Coffs Harbour Bypass

Submissions Report

Volume 1. Executive summary, Chapters 1-3

Coffs Harbour Bypass
Native vegetation
Figure 3.4-1-04

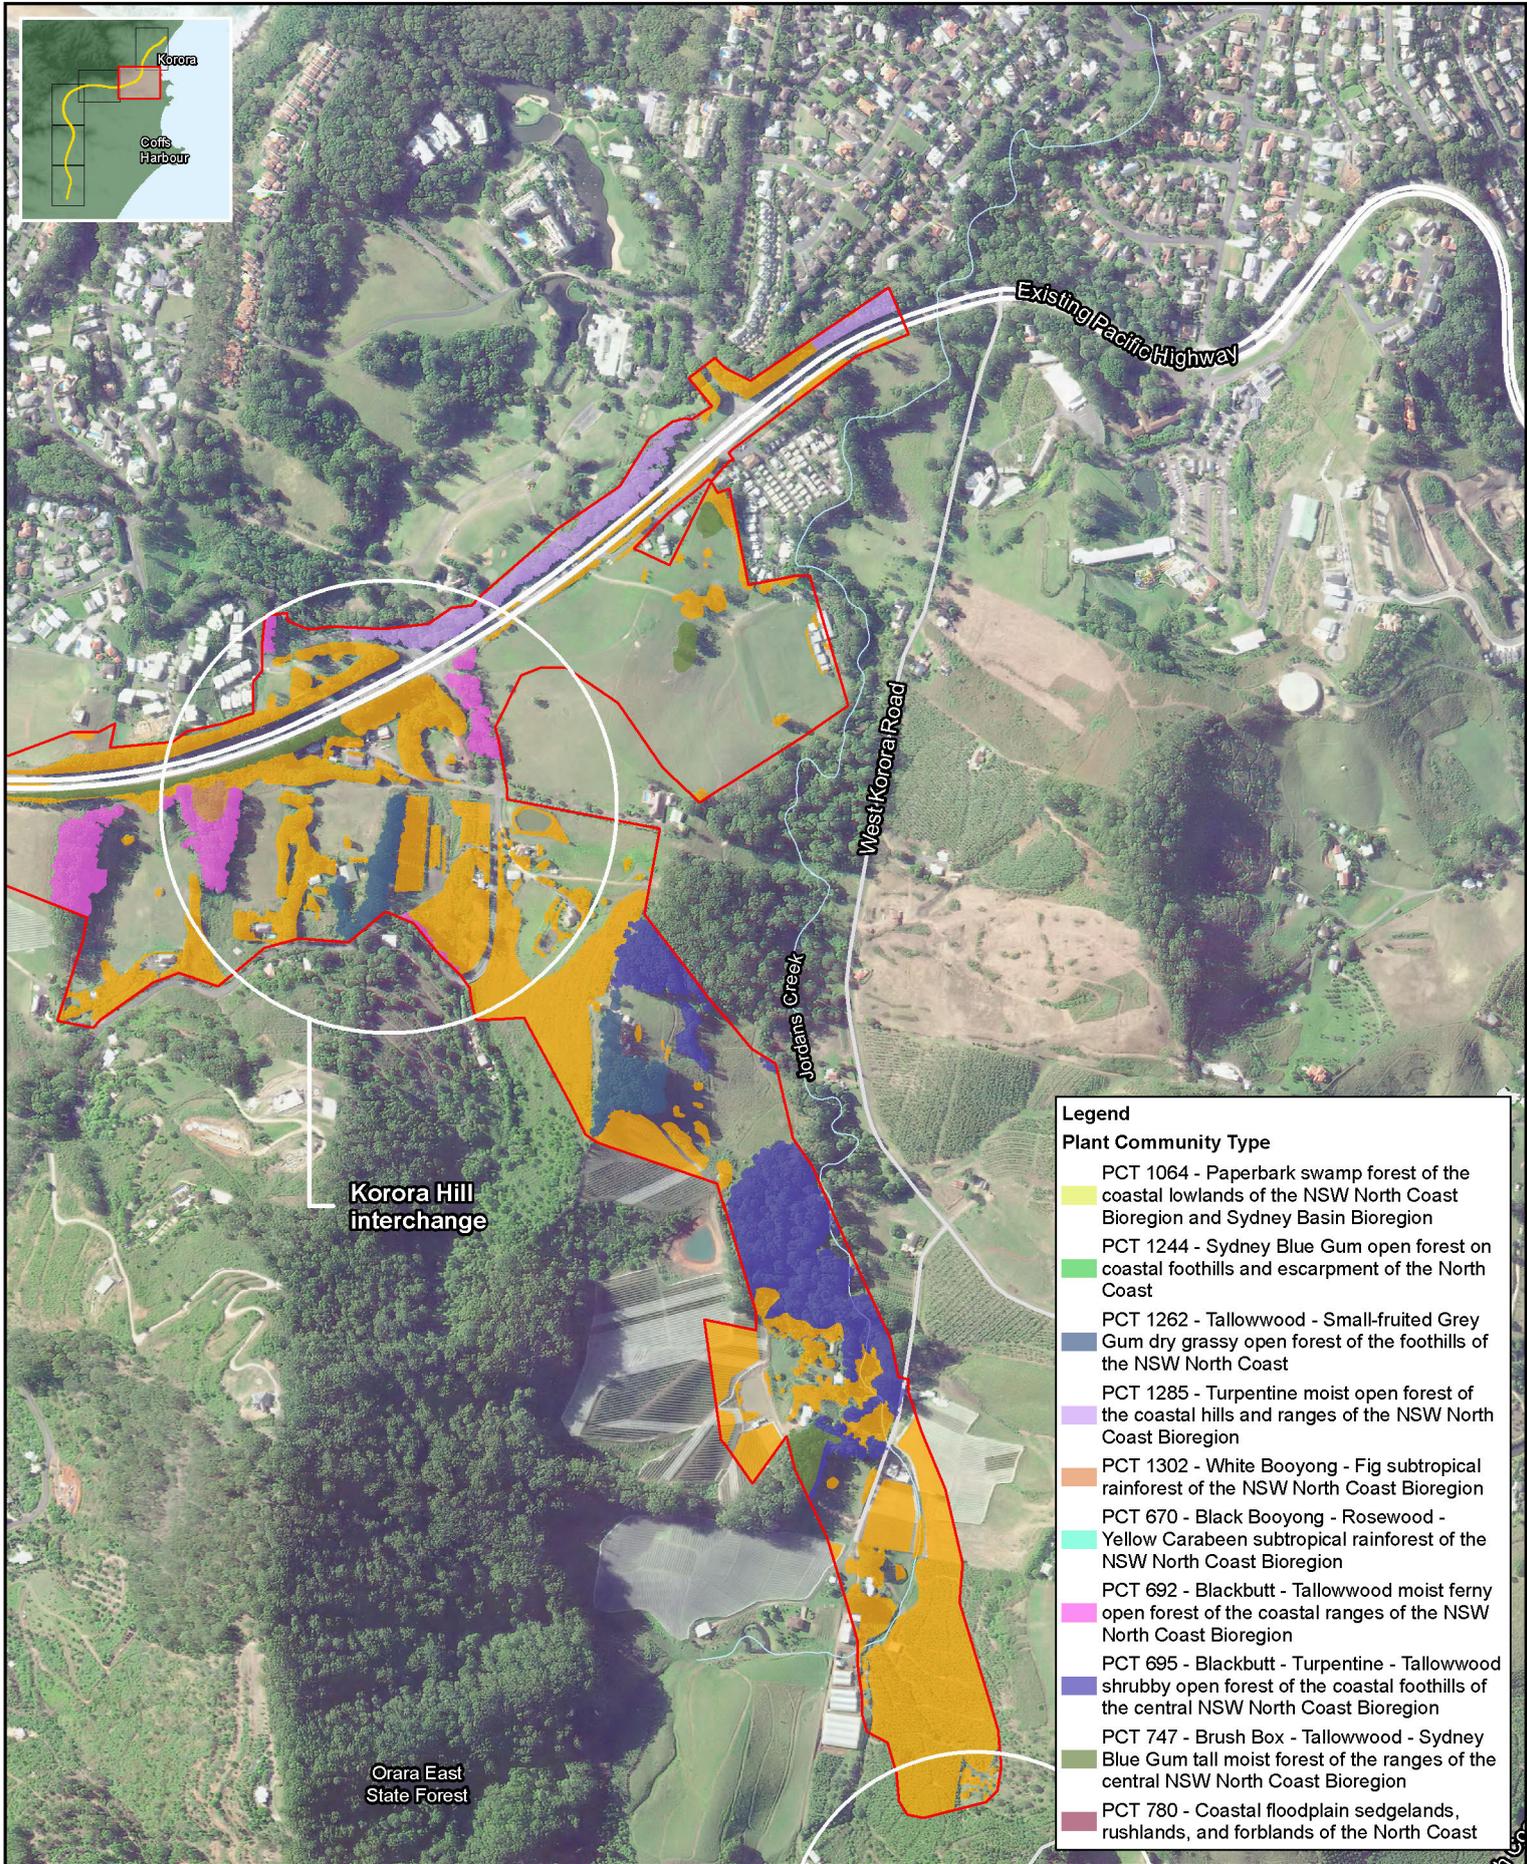
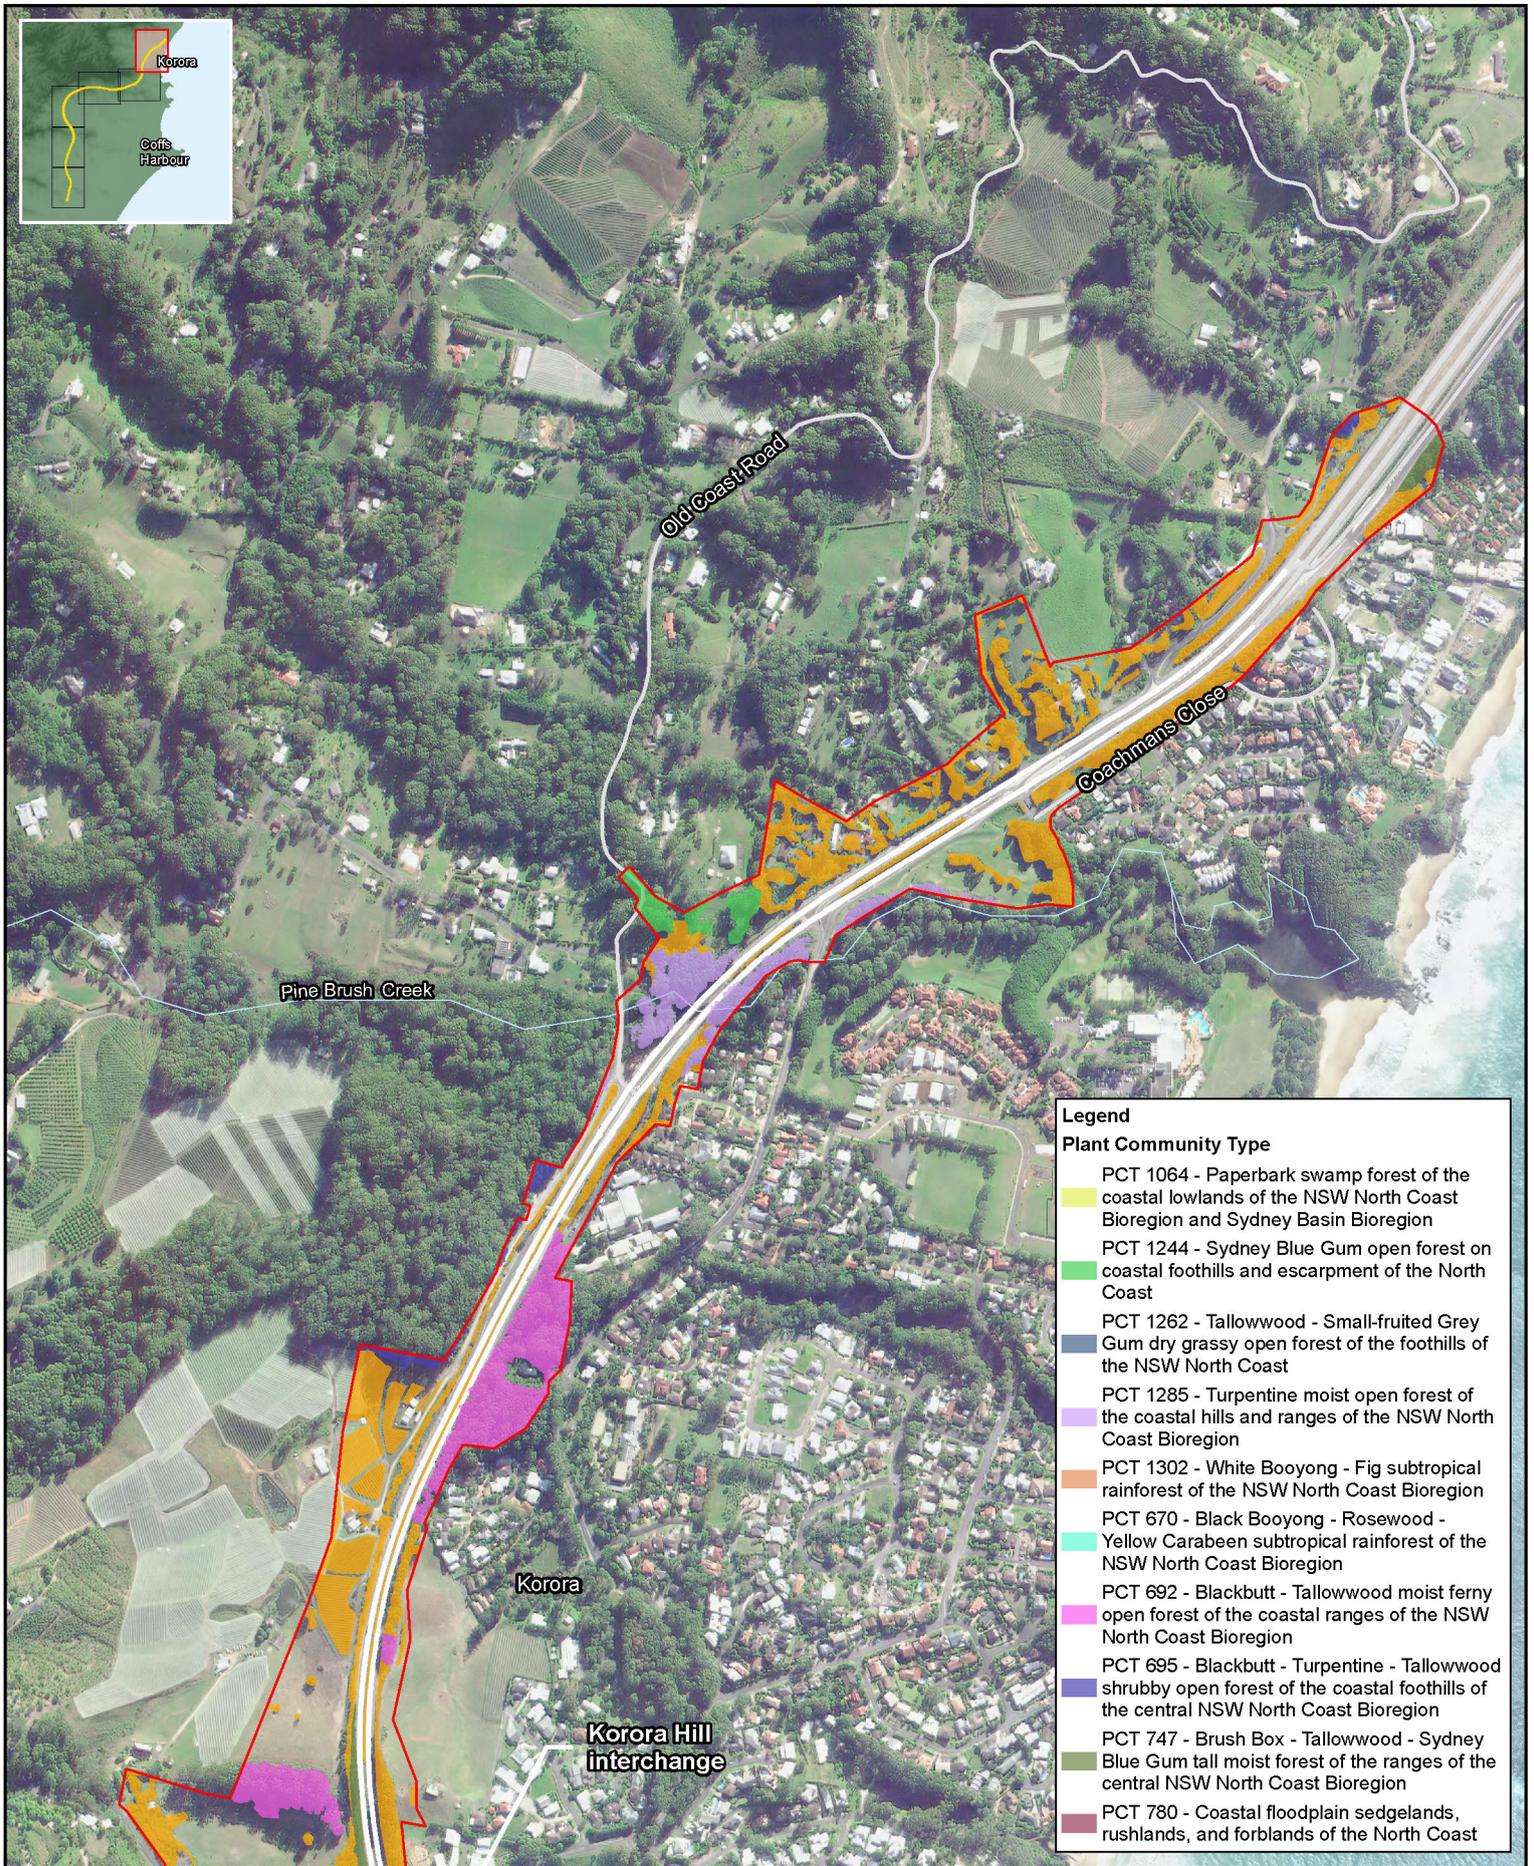
- Any areas of freshwater wetland within the development site must be mapped and assessed, and the results presented in the Biodiversity Assessment Report
- Any freshwater wetlands identified must be assessed to determine whether they align with the freshwater wetland on coastal floodplains endangered ecological community (EEC) determination.

- The two patches of wetland vegetation, north and south of North Boambee Road, have been added because of a change in the condition of the vegetation since the original PCT mapping was carried out in 2016. These areas are described in detail in Section 3.1.2 of Appendix C, Updated biodiversity assessment report of the Amendment Report and shown on Figures 4.1 to 4.7. Locations of updated PCT 780 are provided in **Figure 3.4-1-01** to **Figure 3.4-1-06**.

These areas are described in detail in Section 3.1.2 of Appendix C, Updated biodiversity assessment report of the Amendment Report and shown on **Figure 3.4-1-01** to **Figure 3.4-1-06**.

Figure 3.4-1-01 to Figure 3.4-1-06 shows the extent of vegetation within the study area that has been assessed as urban native/exotic dominant communities. These figures are also included in Appendix C, Updated biodiversity assessment report of the Amendment Report (Figures 4.1 to 4.7). These communities do not have the floristic composition or structure to be assigned a PCT type.

Figure 3.6-1: Typical detail for separating groundwater and surface water at cuttings and tunnels

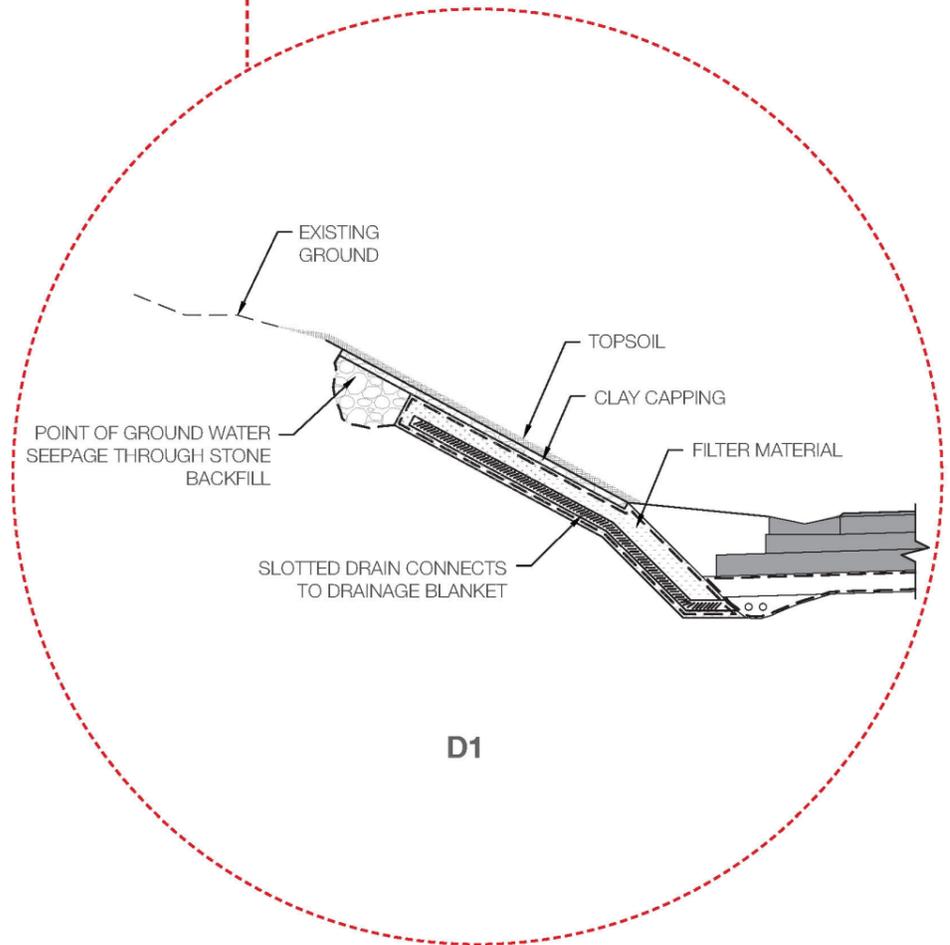
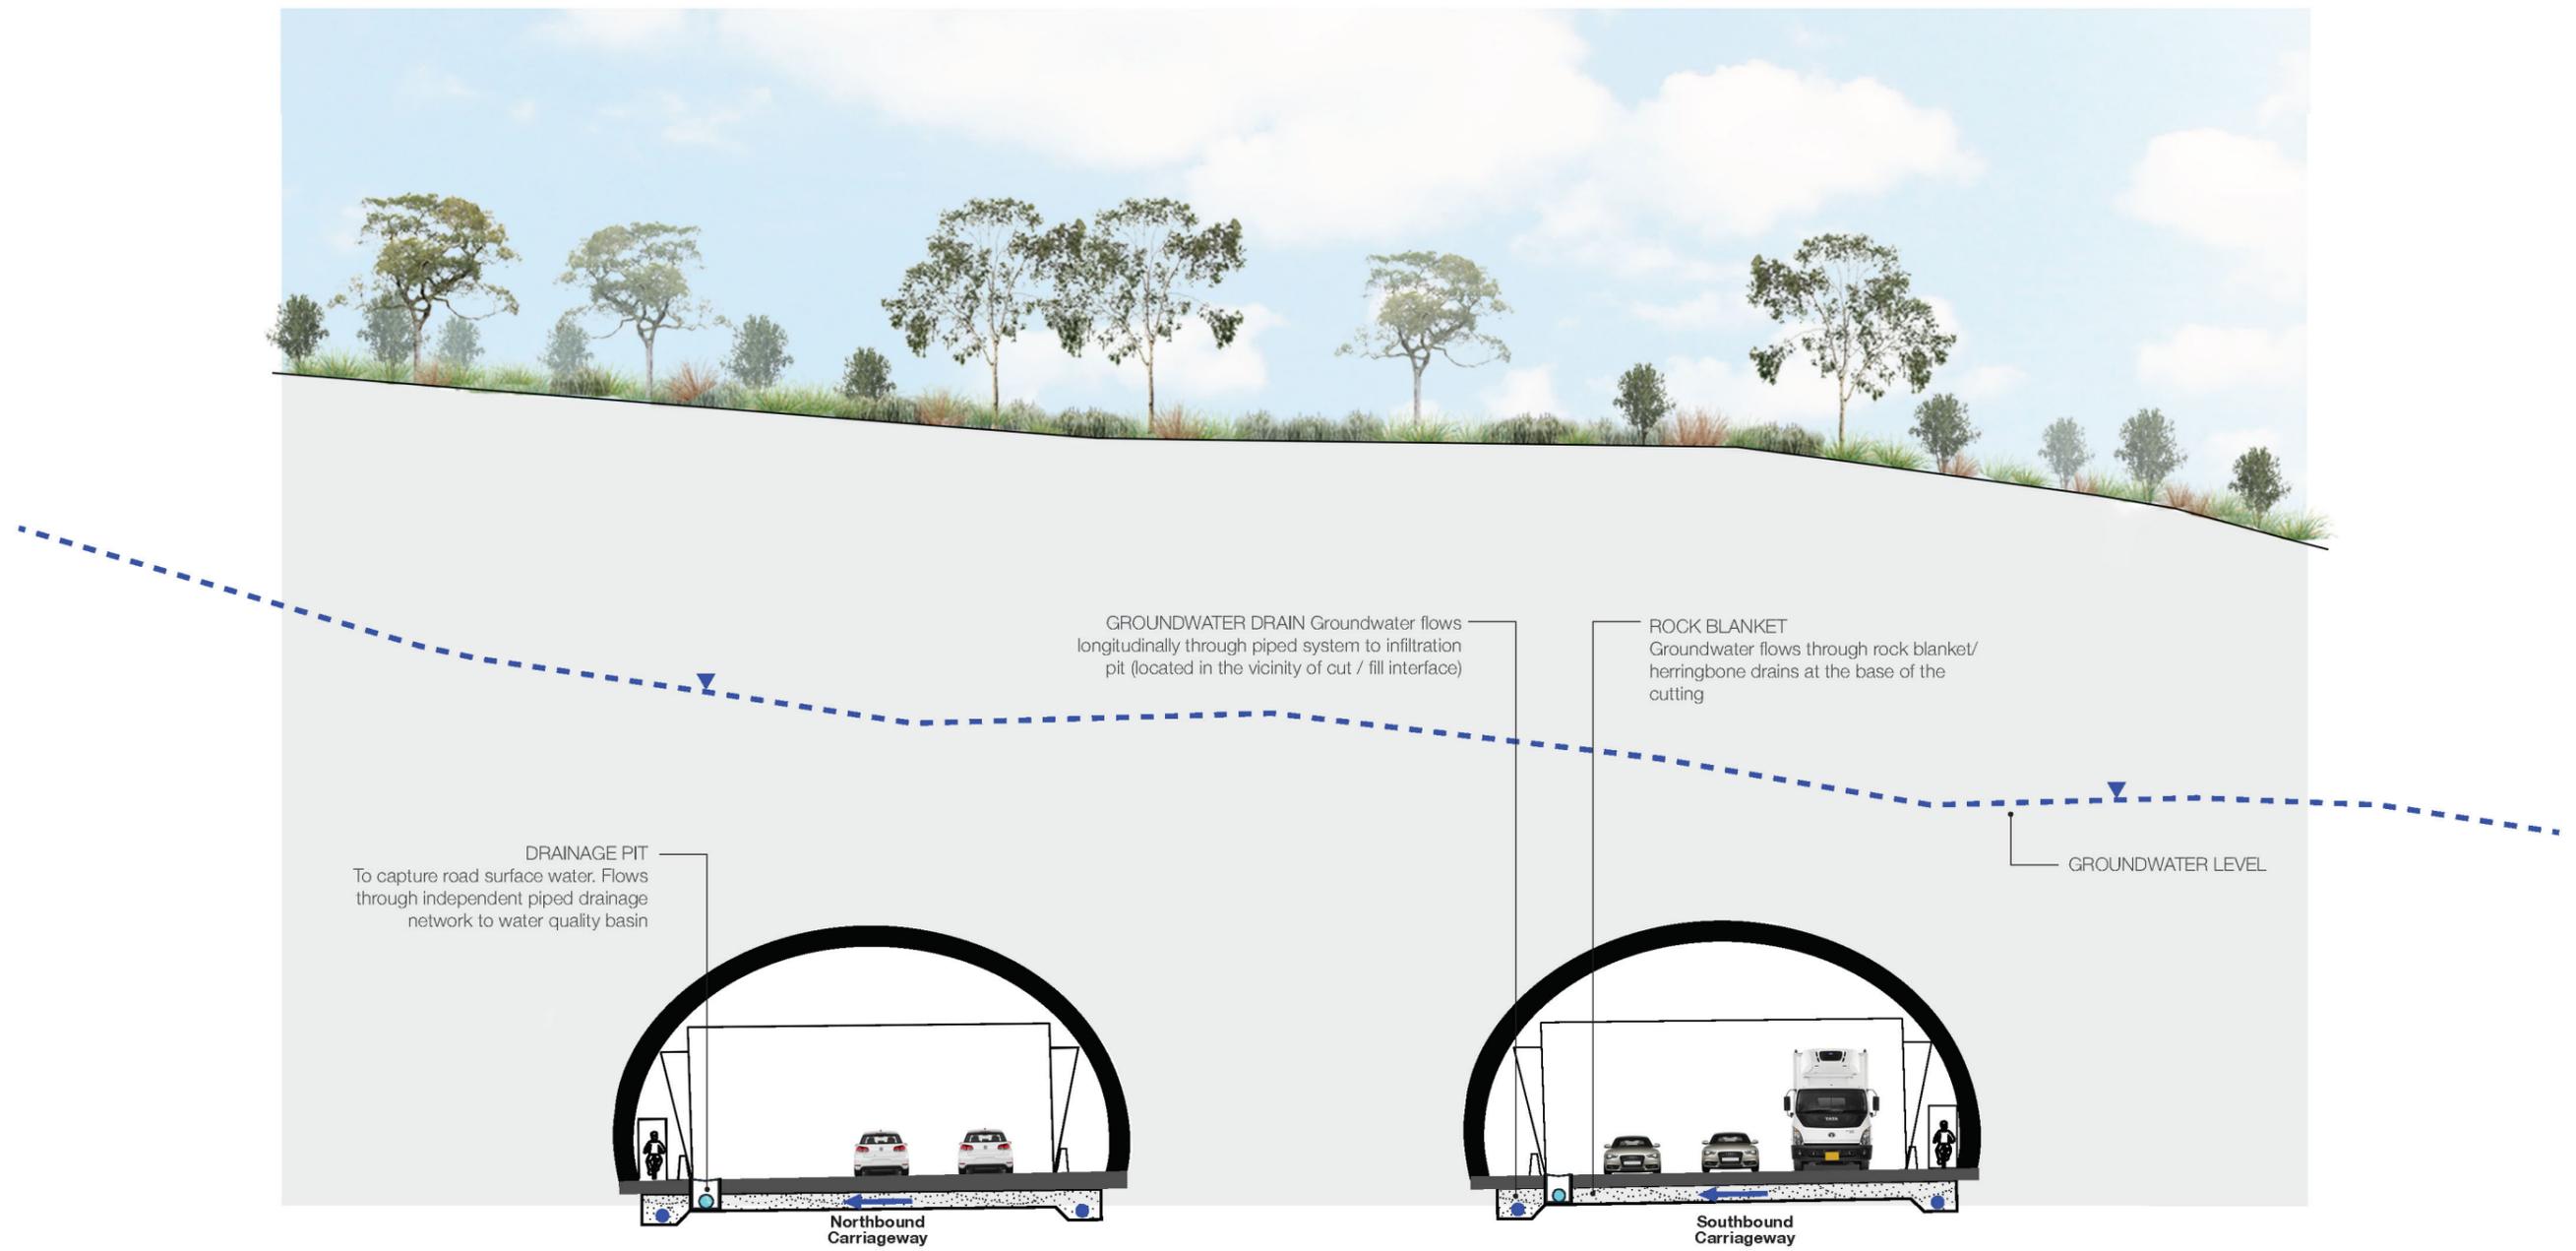
- Throughout the EIS it is detailed that the collection of groundwater inflows into the bypass infrastructure is to be collected via a series of longitudinal pits and pipes and drain towards offsite basins (tunnel water into infiltration basins, cutting water into sediment basins). The EPA understands that once seepage is retained in these basins, collected inflows would then percolate through the pond floor to recharge the underlying strata or discharge into local waterways

- There are concerns relating to the potential for impact as a result of vehicle contaminants and road surface runoff mixing with the cleaner groundwater inflows once the tunnel is commissioned. It is unknown if groundwater seepage drains are to act as clean water diversion conduits on route to the infiltration pits, or if all sources of water within the tunnels and cuttings are to be collected in the same drainage system and treated prior to their storage in the offsite dams

To minimise the potential for groundwater pollution to occur as a result of the project, all groundwater collected at cuttings and tunnels would be segregated from surface run-off (which could be contaminated as a result of road surface run-off). At cuttings, groundwater would be intercepted by subsurface drains installed along the lower part of the cut face, comprising of a permeable stone backfill and slotted drain system (see **Figure 3.6-1**). All captured groundwater would be conveyed to the infiltration discharge basin location through a series of longitudinal drains surrounded by rock fill located below the highway. This drainage system is designed as a clean water diversion for the groundwater, separating it from any surface or road run-off within the cutting, which discharges into a separate surface water drainage system. Surface water run-off will be prevented from entering the subsurface drainage system by a clay capping layer installed over the stone backfill.

All groundwater captured within the tunnel system will be segregated from surface water or road run-off. A drainage system would be installed behind the tunnel face comprising strip drains which would capture groundwater seepage preventing it reaching the tunnel face (see **Figure 3.6-2**). The groundwater would be conveyed to infiltration basins located at the tunnel portals via a longitudinal drain system located below the highway. These systems would be separated from the surface water drainage system within the tunnels.

The proposed drainage design with separation of the groundwater and surface water flows reduces the risk of detrimental changes to the groundwater quality occurring during the operation of the project. As a result, groundwater discharged through infiltration basins would be the same quality as that prior to capture within the tunnel or cutting.
